Ward: Ramsbottom

Item 01

Proposal: Variation of condition 2 (approved plans) on planning permission 69702 (Demolition of existing industrial buildings and erection of 3 no. detached dwellings): Revision to elevations and design

Application Ref: 72678/Full

front elevation

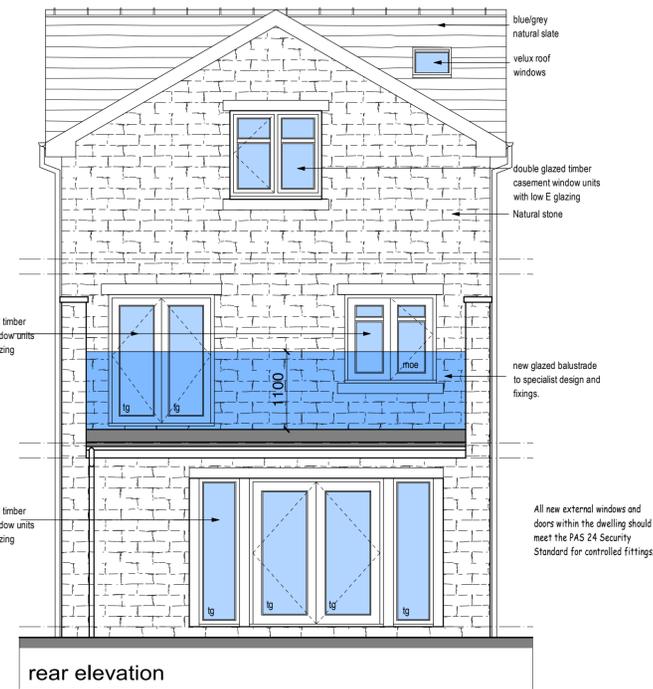
The front elevation would retain the traditional and historic features of the approved application and materials used in the development would be the same as previously approved, to provide natural stone elevations, double glazed timber casement windows and natural slate roofs.

This proposed variation of condition would remove the overly contemporising features from the front elevation; non-uniform window openings, irregular fenestration patterns and proportions and the stone roof copings. The rear elevation is more contemporary in its features as previously described. The rear elevation has been reassessed with regard to its visual impact and visibility in the street scene. It would not have the same visual prominence as the front elevation in the street scene. The National Planning Policy Framework (NPPF) requires at paragraph 210 c) the desirability of new development making a positive contribution to local character and distinctiveness. The new development would be marked improvement to that part of the conservation area, replacing poor quality industrial buildings.

rear elevation

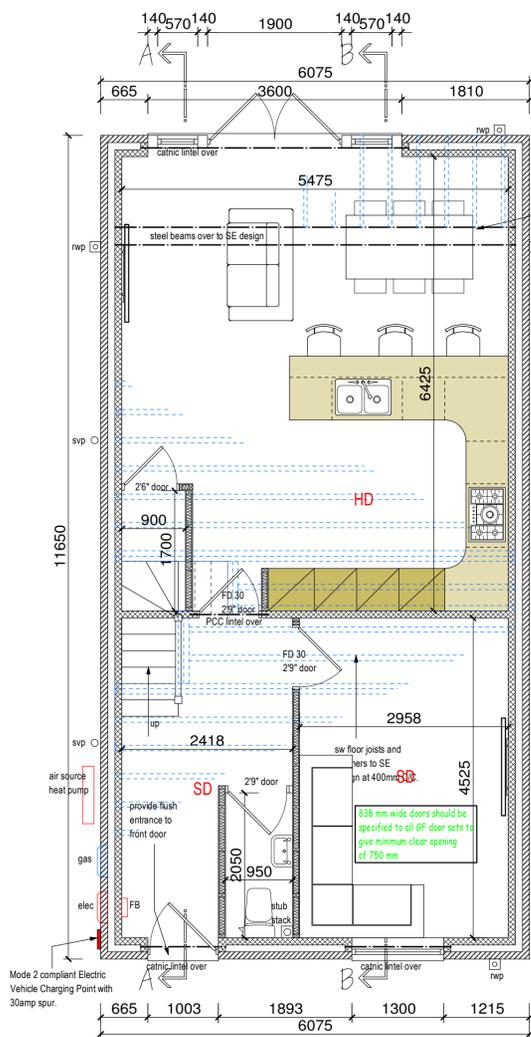
It is now proposed to extend the footprint of the dwellings by 1.5m at the rear and add a balcony at the first floor which would be accessed from the principal bedroom. (The width of the property would remain the same). Window openings on the rear elevations would have a more contemporary design.

The rear elevations would not be highly visible to public views and would be mostly screened by a retaining wall and mature tree planting to the land beyond. It is therefore considered these alterations would be acceptable.

This application for a variation of condition has proposed a more contemporising rear elevation with a rear facing gable, balcony and bi-fold doors at the ground floor, but with a traditional front elevation.

As such it is considered that with the improvement to the front elevation and the now reassessed lesser visibility of the rear elevation in the street scene, the amended house design as a whole would preserve the character and appearance of the conservation area and as such it acceptable with regard to heritage conservation.
